From: Jon Holan
Sent: Thursday, June 22, 2017 10:04 AM
To: Michael W. Kinkade; Janie Schutz; Rob Foster
Cc: Jesse VanderZanden; Daniel Riordan
Subject: Road Grades and Emergency Vehicles in David Hill area

At the last Council meeting, CD staff made a presentation on the Westside Plan. One comment we received from Councilor Rippe had to do with street grades, impact on emergency services and safety concerns as the collectors approach intersections. He was concerned about the impact on response times due to the increase in slope and the impact of icy conditions on safety due to steeply sloped roads. He was expressing the need to have roads designed to follow contours.

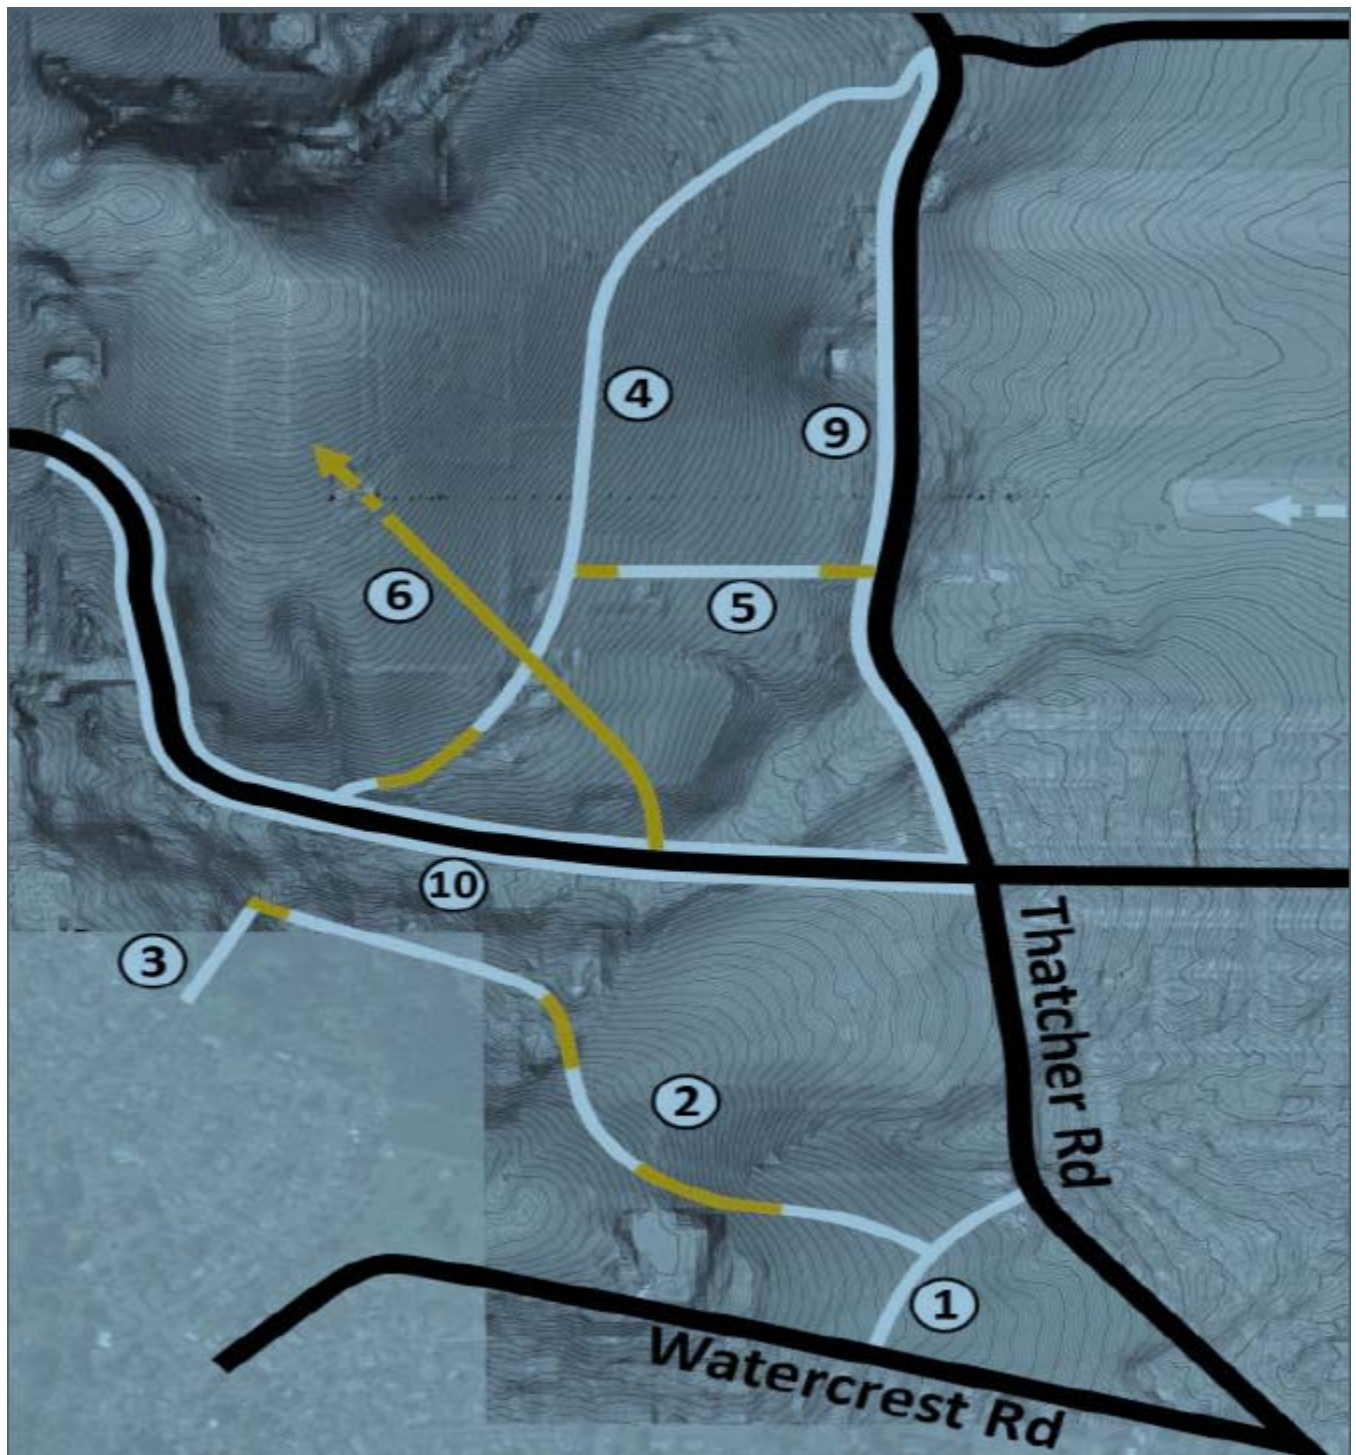
The tradeoff from these policies is to minimize environmental impact in exchange for some roadways having steeper slopes of up to 15%. The roadways in yellow on the map below shows the potential roadway segments which appear to exceed 12% (but no greater than 15%). *Keep in mind that this is looking at the 50,000 foot level and not based on anything too precise in terms of road location or slopes.*

Michael and Janie: What impact on emergency response is there on road slopes greater than 12% and is there a maximum distance over 12% that should be imposed? (I presume this is would mainly be a Fire response issue but also wanted Police input as well. Simply saying “the less the better” is not a response as we all want to minimize this as much as possible. The development type would be single family dwellings with the possibility of condos in the triangle area of roads 5, 6 and 10.)

Rob: Will a 20 foot long landing be adequate in icy conditions and should the landing requirement be extended (of so, for how much)?

Interesting question and a first in my career to get, so thanks, I think. ☺ In regards to police response, the grade of the road, at the levels you are asking about, would not have a significant impact on our operations with the current fleet of vehicles we have. Currently, we are slowly transitioning over to Ford Explorers with all -wheel drive, along with changing over to a different snow tire. I'm not super knowledgeable on this topic, but I am confident that our current fleet assets will be able to traverse the roadway, regardless of the incline, in adverse conditions with the appropriate traction control devices.
